Subject: Dresden Station Units 2 and 3  
Response to SEP Request for  
Additional Information on Spent  
Fuel Storage Racks  
NRC Docket Nos. 50-237/249

RESPONSE TO NRC SYSTEMATIC  
EVALUATION PROGRAM BRANCH'S  
REQUEST FOR ADDITIONAL INFORMATION  
ON DRESDEN UNITS 2 AND 3 SPENT FUEL  
POOL STORAGE RACKS DATED MAY 13, 1981

Figure 1.1 Rack in Impact Configuration

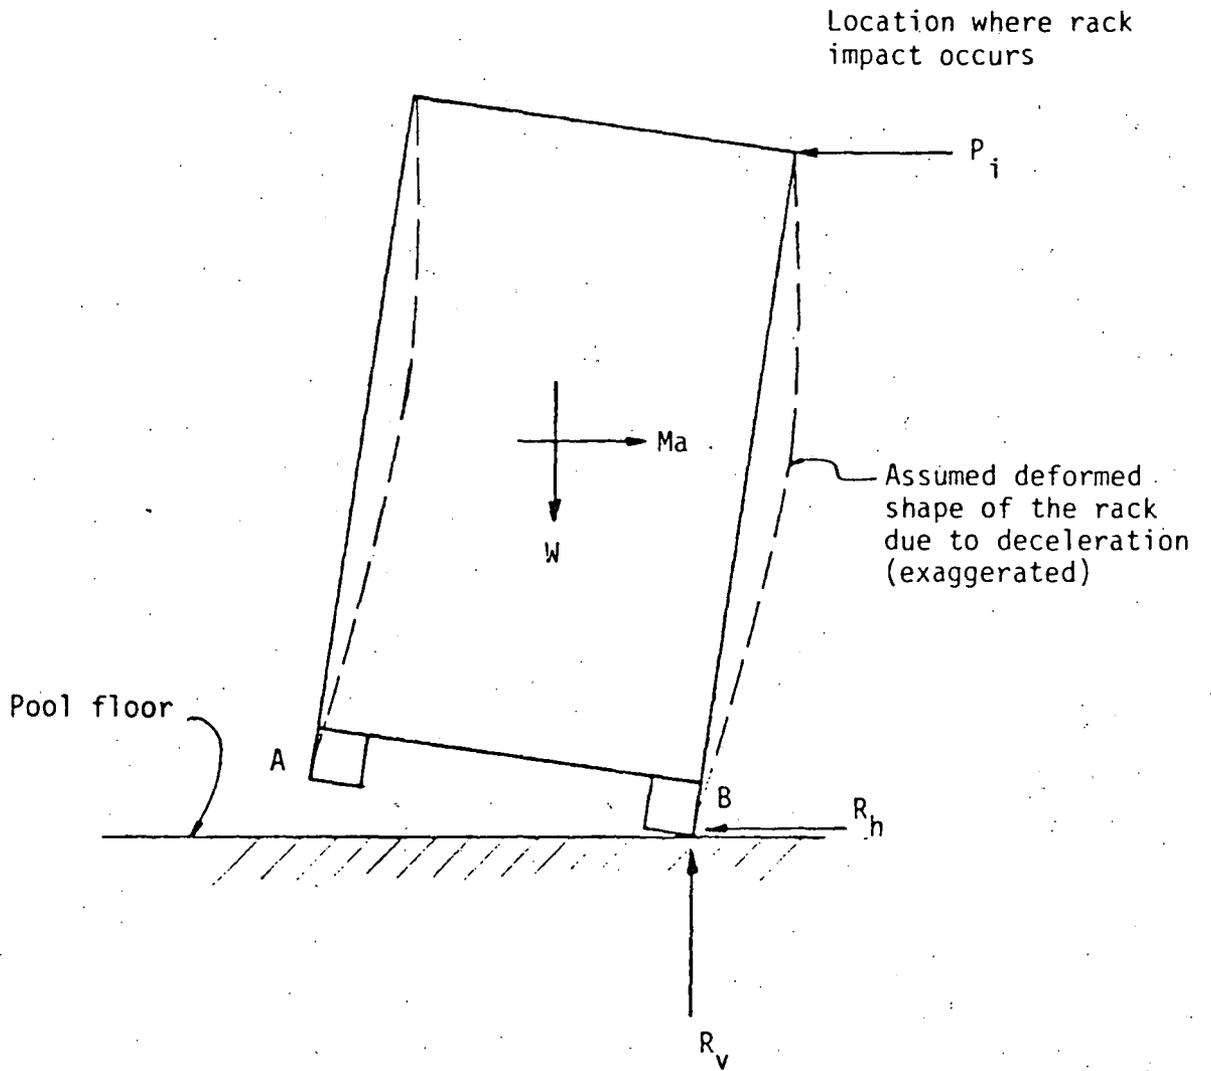
Verify that the horizontal velocity used in the rack-to-rack impact evaluation was that from the nonlinear analysis of the empty rack with the 0.2 coefficient of friction between the rack legs and pool floor. Revise Table 3.4-2 to reflect any increases in stresses in the overall rack structure under such a condition, as appropriate. Clearly state and justify all assumptions made in your analysis.

The rack-to-rack and rack-to-pool wall impact during rocking would occur at the top edge of the racks (see Figure 1.1). Using an energy-balance method, and assuming elasto-plastic behavior of the tube walls, analysis of rack-to-rack and rack-to-pool wall impact was performed for a fully loaded 9 x 13 rack (which is the most critical) with an impact velocity of 13.0 in/sec. The maximum impact force ( $P_i$ ) developed at the top edge of the rack during the impact was equal to 48.51 kips, and the maximum deceleration ( $a$ ) of the rack was 0.4g. These values were obtained assuming that during the impacts, the change of the impact force and the deceleration were linear, and the rack would completely stop at the end of the impact (no rebound was assumed, hence conservative).

The reaction forces ( $R_v$ ,  $R_h$ ) induced at rack legs (shown in Figure 1.1) would vary with the actual coefficient of friction between the rack legs and pool floor. Using a friction coefficient of 0.75, these reaction forces were computed as shown in Table 1-1. As reported in the licensing report,

On the basis of preceding analysis, it is concluded that stresses in the overall rack structure under rack-to-rack and rack-to-pool wall impact conditions are not as critical as the stresses shown in Table 3.4-2 with the exception of tube walls near the top edge of the rack, where localized plastic deformation may be expected due to impact.

Figure 2.1 Rack in Rocking Position

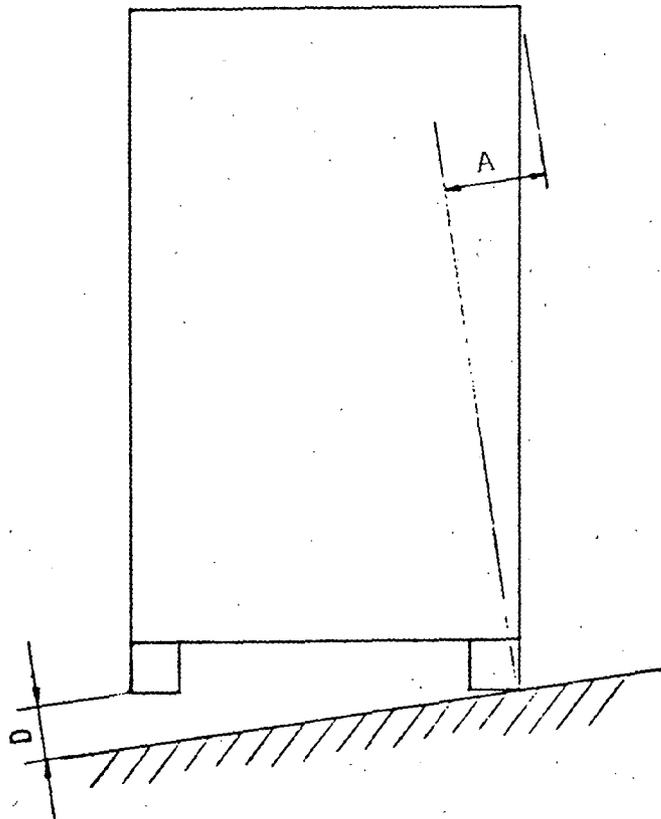
Provide the results of your analyses to demonstrate that the 4.625-inch minimum gap between the racks and pool wall is adequate (provides for the minimum factors of safety against impact stated in Standard Review Plan Section 3.8.5) considering both rocking and sliding of the racks under all postulated rack loading conditions and considering the variations in the coefficient of friction between the rack feet and pool floor. If such impact cannot be precluded, demonstrate that the local and gross effects on the racks and pool wall are acceptable. Revise Tables 3.4-2 and 3.5-2 to reflect any increase in loads and stresses as appropriate. Clearly state and justify all assumptions made in your analyses.

From the nonlinear analysis of an empty 9x13 rack (considering both rocking and sliding effect and assuming 0.2 coefficient of friction between the rack legs and pool floor) for a SSE motion in the short direction of the rack, the maximum lift-off at one side of the rack and relative horizontal displacement at top of the rack due to rocking (shown as D and A in Figure 2.1) were 0.56 in. and 2.01 in., respectively (See Table 2-1); the sliding distance of the rack was 1.012 in. (Refer to page 3-38, Licensing report NSC-COM-0219-R001). Thus, the total displacement at the top of the rack was computed to be 3.022 in. Hence, the factor of safety against the empty rack impacting the pool wall is  $(4.625 \div 3.022 =) 1.53$ . Energy-balance method was then used to compute D and A values of the rack due to rocking for various assumed loading conditions. In this approach, vertical displacement of the center of gravity (cg) of the rack was determined by equating the kinetic energy of the rack to the work required for raising the cg of the rack. The results obtained are summarized in Table 2-1. Study of the values given in Table 2-1 showed that: (a) Energy-balance method gave very conservative results when compared with results from nonlinear analysis. Thus, the factor of conservatism when energy-balance method is used may be estimated as  $(6.96 \div 2.01 =) 3.46$ , (b) If this factor of conservatism is taken out for the partially loaded cases, the maximum value of A would be 2.26 inches only.

Thus, the maximum total displacement at the top of the rack would be equal to  $(2.26 + 1.01 =) 3.27$  inches. Therefore, it can be concluded that the minimum factor of safety against impact (1.1) as stated in Standard Review Plan Section 3.8.5 for SSE motion is met and impact of racks on pool walls is not anticipated. However, to demonstrate that additional margin exists, the pool walls were evaluated assuming that impact of racks may occur. The method of analysis used and assumptions made are presented in the following paragraph.

Figure 3.1 Force-Displacement Function for Pool Slab

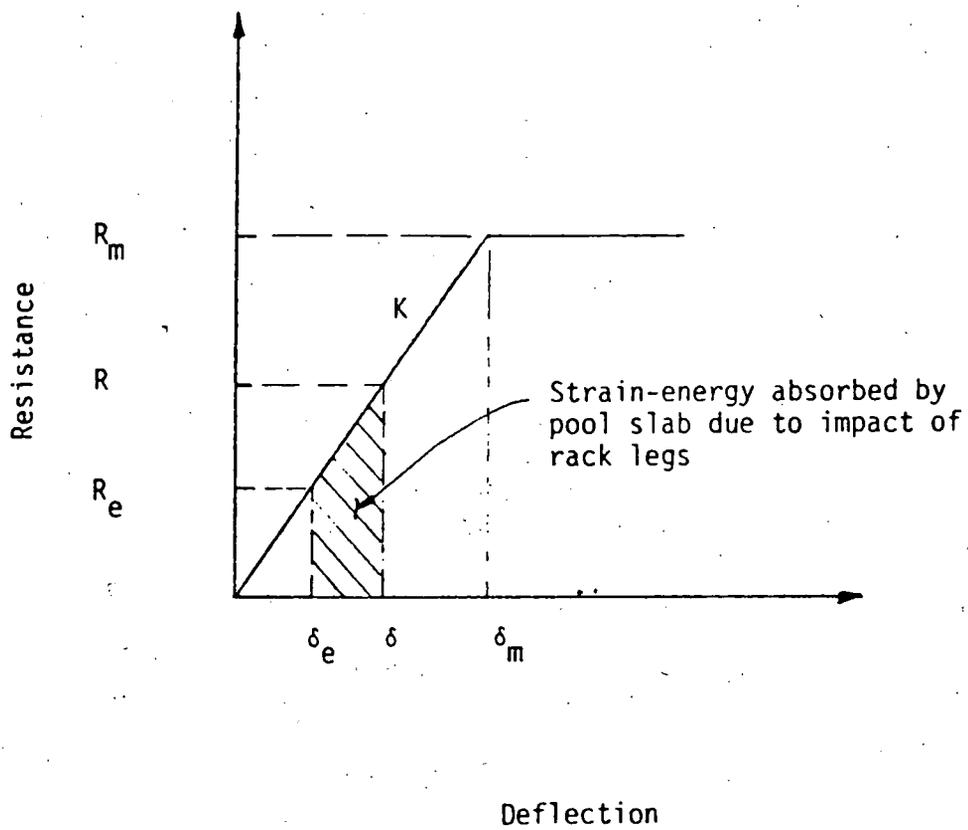
Considering both rocking and sliding of the racks under all postulated rack loading conditions and considering the variations in the coefficient of friction between the rack feet and pool floor, provide the results of your analyses to demonstrate that the local and gross effects of the uplift and resulting impact of the rack legs with the pool floor are acceptable for both the rack and pool slab structures. Revise Tables 3.4-2 and 3.5-2 to reflect any increase in loads and stresses, as appropriate. Clearly state and justify all assumptions made in your analyses.

For the purpose of analyzing the pool slab subject to impact of rack legs, the pool slab was idealized as a single degree-of-freedom system with force-displacement characteristics as shown in Figure 3.1. The parameters related to this force-displacement characteristic were then determined for the pool slab and the following values were obtained:

- (a) Maximum resistance ( $R_m$ ), computed on the basis of ultimate moment capacity of the pool slab, was equal to 30016.8 kips.
- (b) Elastic spring constant ( $k$ ) was 382100 kips/in. The effect of concrete cracks was also taken into consideration.
- (c) Total existing uniform load ( $R_e$ ) acting on the pool slab was 8334.5 kips. Weights of water, slab, loaded racks and loads resulting from SSE are all included.
- (d) Corresponding displacements of the pool slab were 0.0786 in. for  $\delta_m$  and 0.0218 in. for  $\delta_e$ .

Using energy-balance method (i.e. total strain-energy absorbed by the pool slab minus the strain-energy due to existing loads equals the input kinetic energy resulting from impact of rack legs), the final deflection ( $\delta$ ) and applied load ( $R$ ) on the pool slab were obtained. These values were 12707 kips (for  $R$ ) and 0.0333 in. (for  $\delta$ ), respectively. The shear capacity of the pool slab was investigated to determine the margin of safety against shear failure. Based on the ultimate shear capacity due to diagonal tension at a distance equal to effective depth of pool slab, the ultimate load capacity for the pool slab was computed to be 17643 kips. Therefore, the pool slab remained within the elastic range and was safe from shear failure while subjected to impact of rack legs.

Figure 4.1 Showing Location of CG of 9x13 Rack

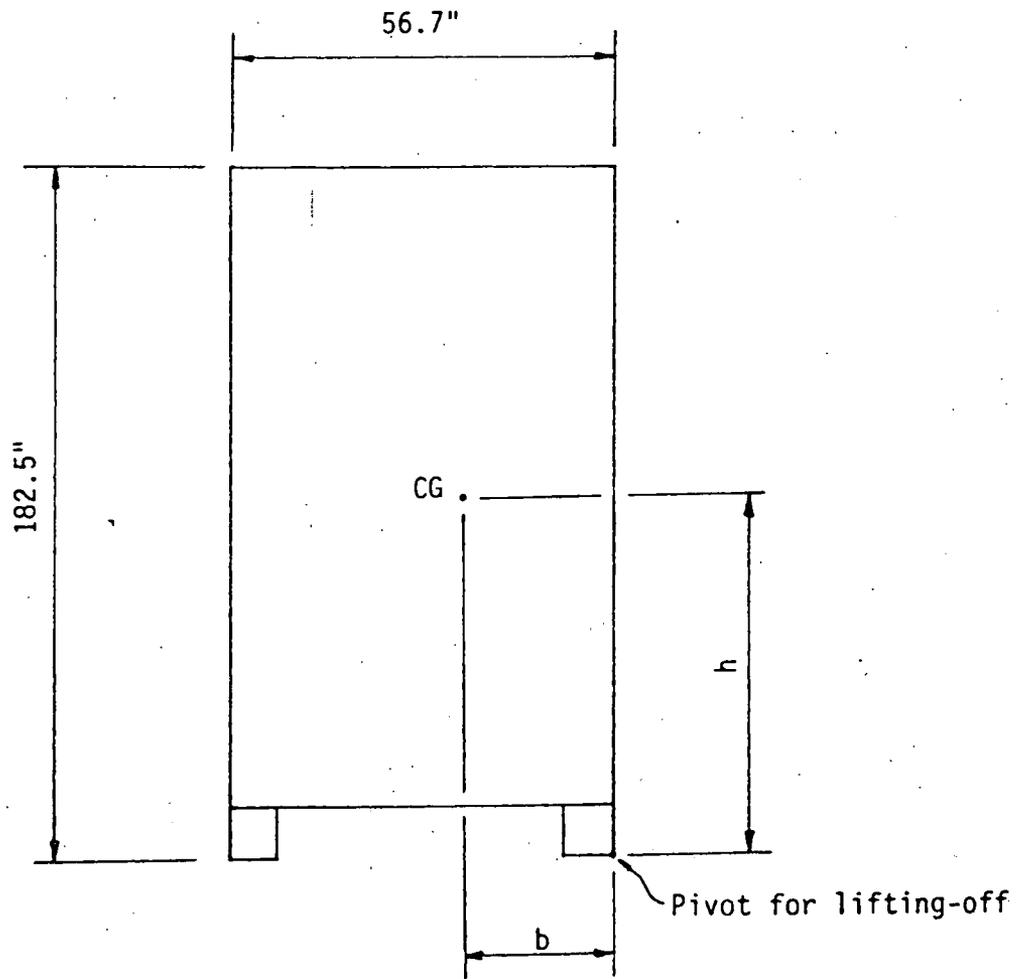
For all loading conditions considered in the above analyses, provide the location of the center of gravity assumed.

The location of the center of gravity (cg) of racks for various loaded condition considered in the preceding analyses are as follows (see Figure 4.1 for symbols):

- (a) For empty rack and fully loaded rack, b is 28.35 inches and h is 97.13 inches.
- (b) For rack loaded with one row of tube cells on pivoted side of the rack, b is 18.1 inches and h is 97.13 inches.
- (c) For rack loaded with two rows of tube cells on pivoted side of the rack, b is 15.58 inches and h is 97.13 inches.
- (d) For rack loaded with three rows of tube cells on pivoted side of the rack, b is 15.62 inches and h is 97.13 inches.
- (e) For rack loaded with four rows of tube cells on pivoted side of the rack, b is 16.8 inches and h is 97.13 inches.
